PLANNING AMENDMENT

Application No. H06/1066/00.

ERECTION OF BUNGALOW & DOUBLE GARAGE.

Planning Application H06/1066/00.
Erection of bungalow and double garage, Plot 1, Marsh Road, Gedney Drove End – Mr R R Kirk.

DWG Nº 7642/SP10 SCALE 1/250 ASHBY & PERKINS. WISBECH

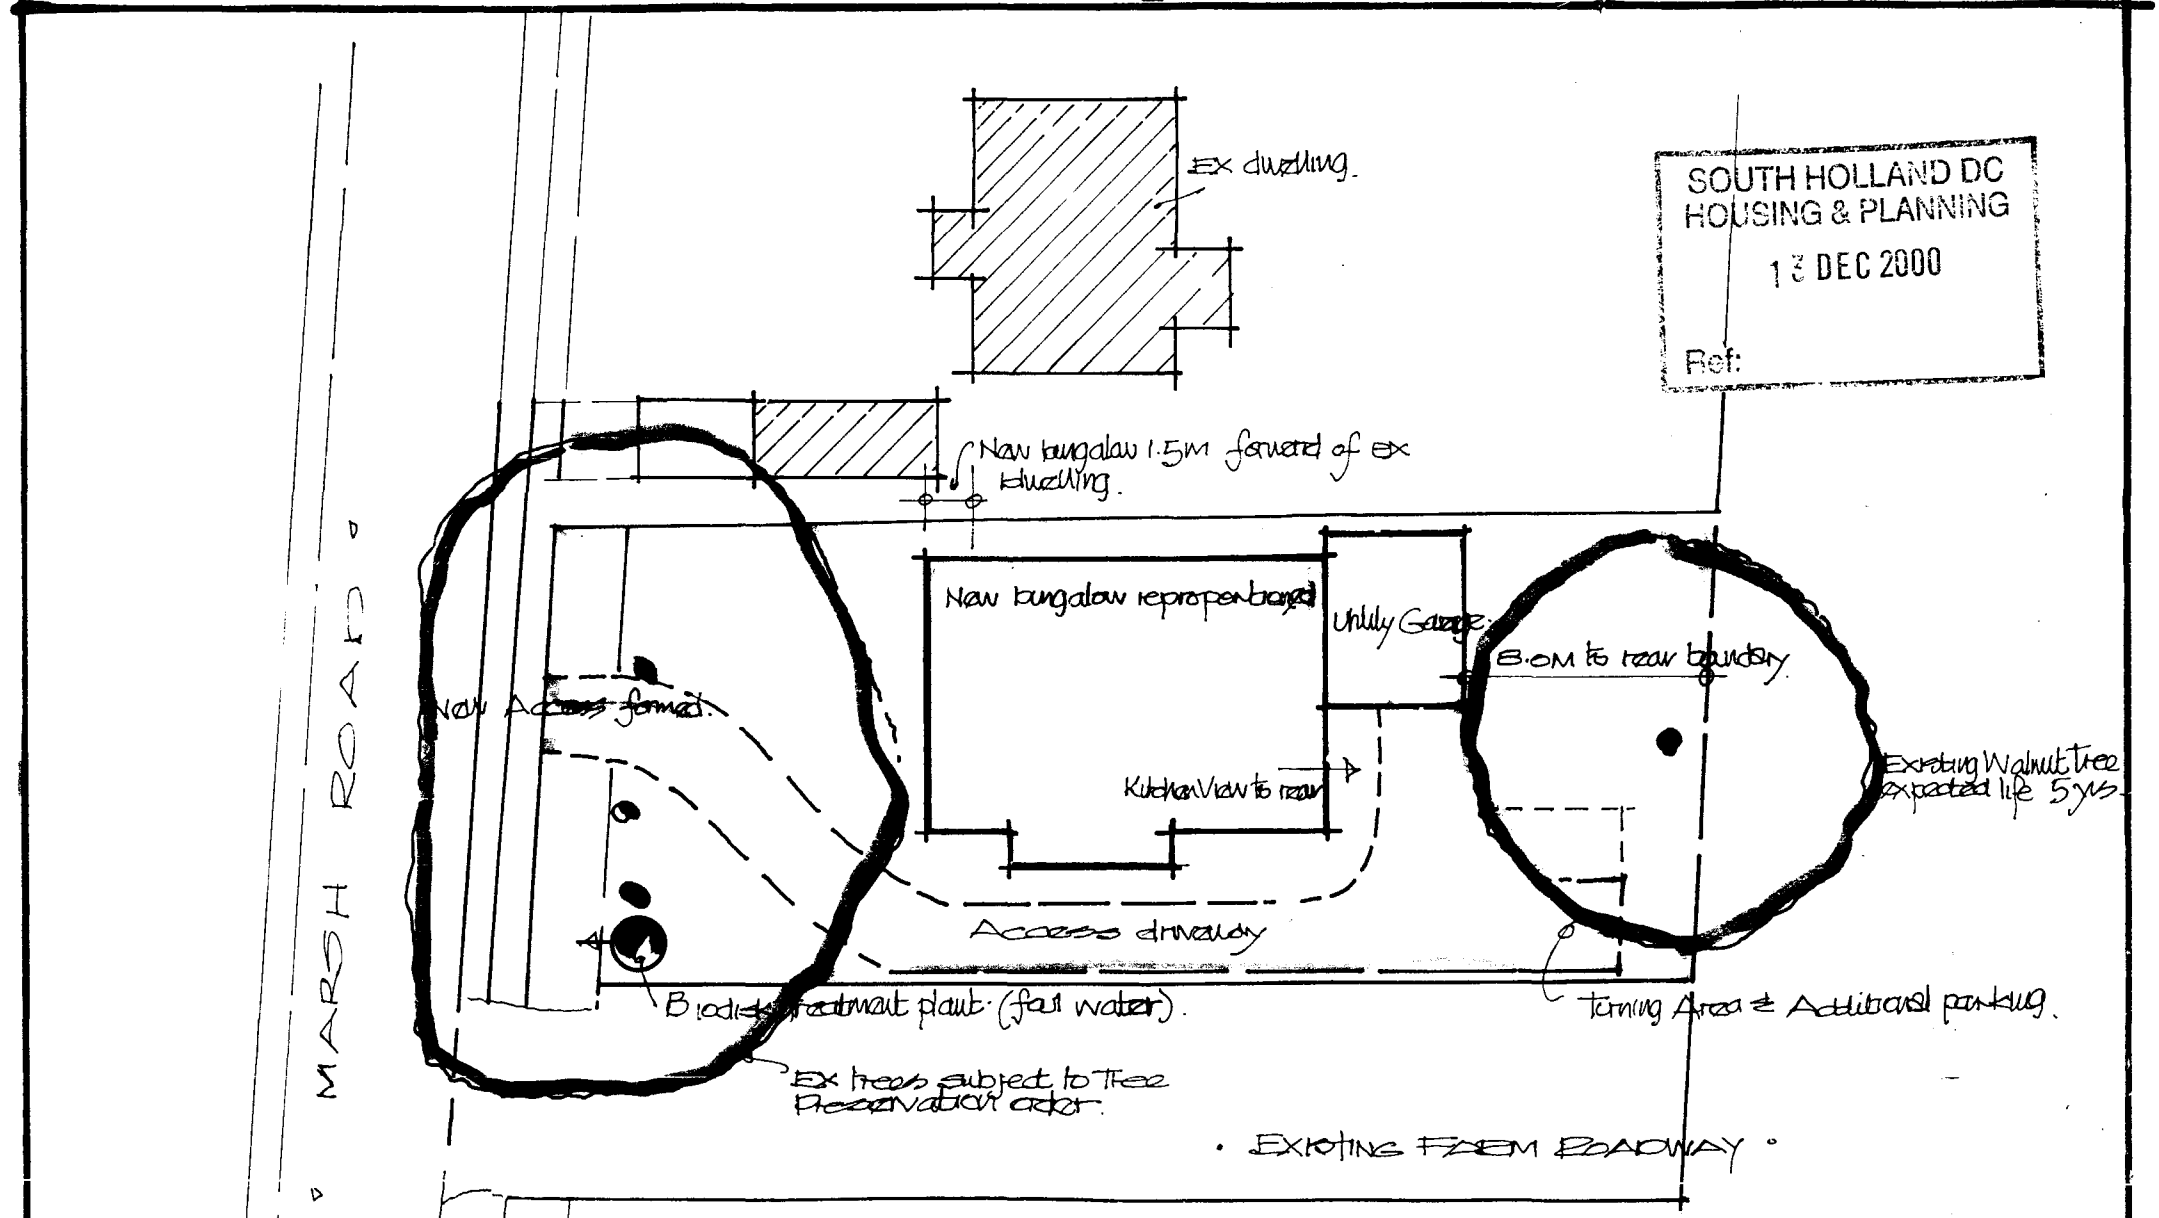
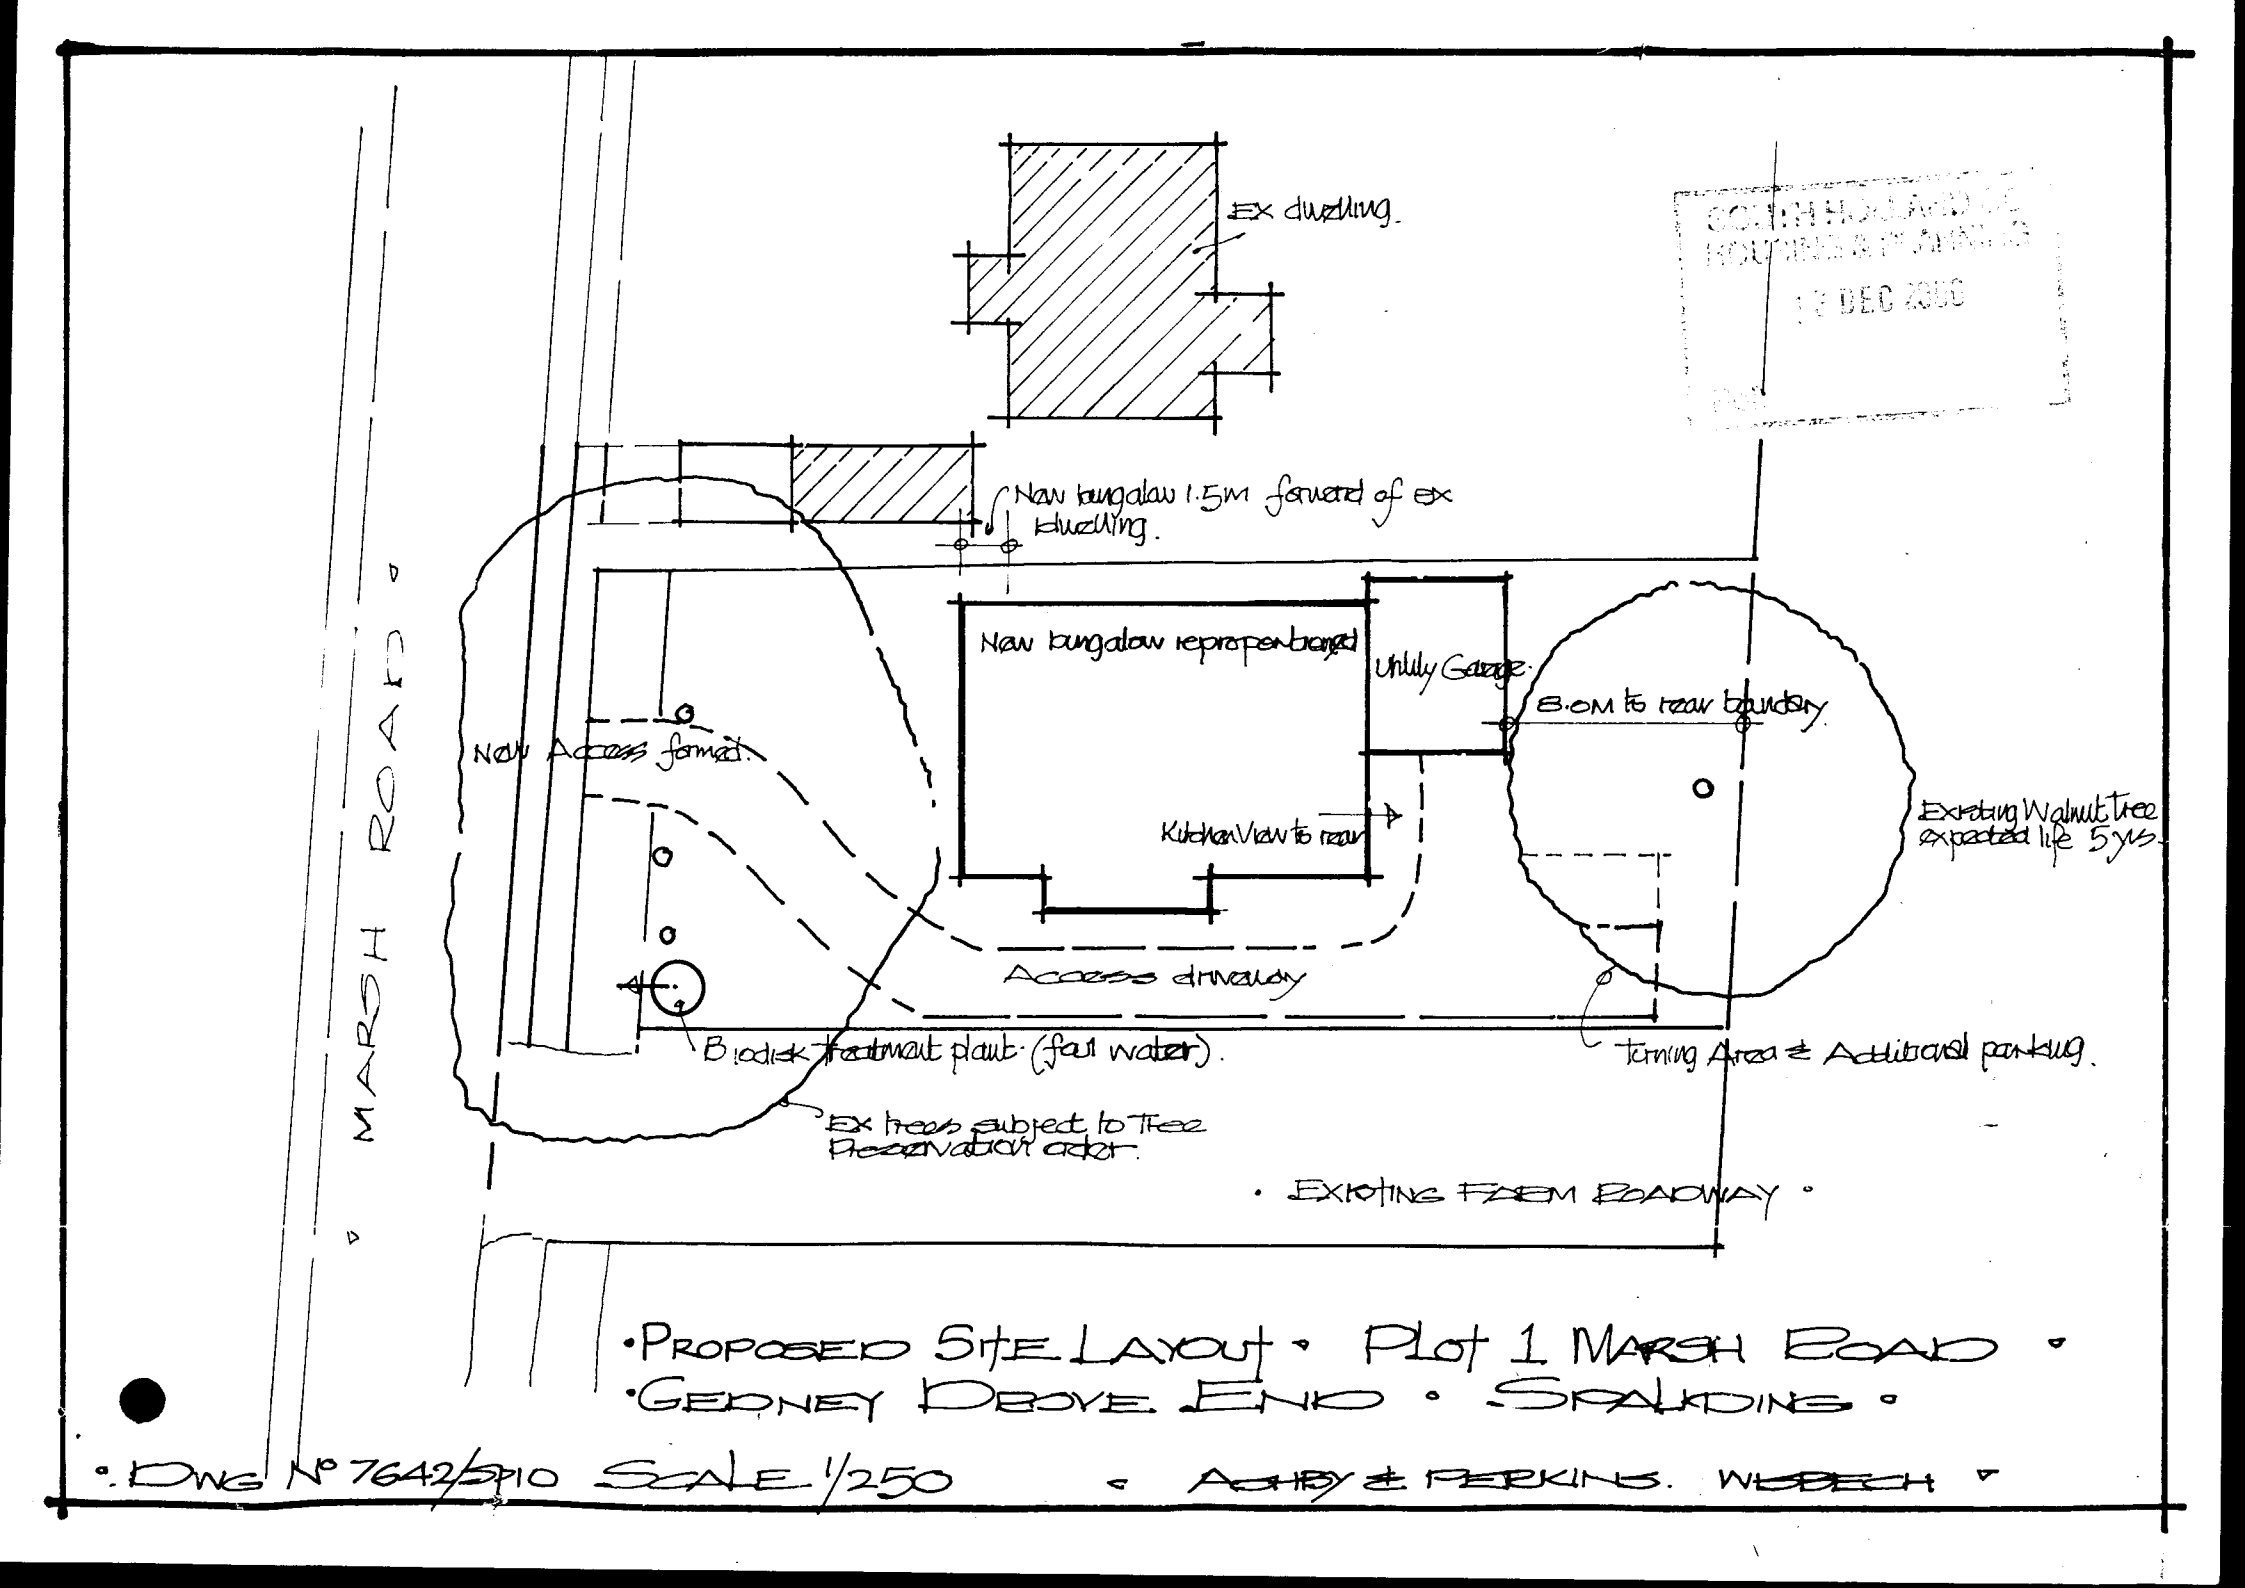
I write further to a conversation with Mr Perkins on 14 December 2000 and look forward to receipt of amended plans showing the garage at least 1 metre from the northern boundary, as discussed.

Following our recent site visit to the above site I have spoken at length with Mr Adams of Building Control dept. who confirms that the adjoining plot has gained a conditional BR consent for a Septic Tank, requiring 60.0M length of soakaway drains or a private treatment plant it would appear that only a private plant is practical, my client will adopt this system which will be sited in the front garden.

2. I have revised the bungalow & reproportioned the overall size to achieve a depth of some 1.5M less depth. which enables Mr Kirk to gain a view to the fields at the rear, the walnut tree on the rear boundary will not be effected by Foul water drains & I am now able to provide a turning & parking area.

3. the building line has been set back as agreed on site to a line some 1.5M forward of the existing house on the adjoining plot, this gives a distance of 8.0M from the garage to the rear boundary as amenity area.

I enclose herewith 2 copies of revised layout plan showing the above points. I feel this siting & scale is more appropriate & gives a standard very similar
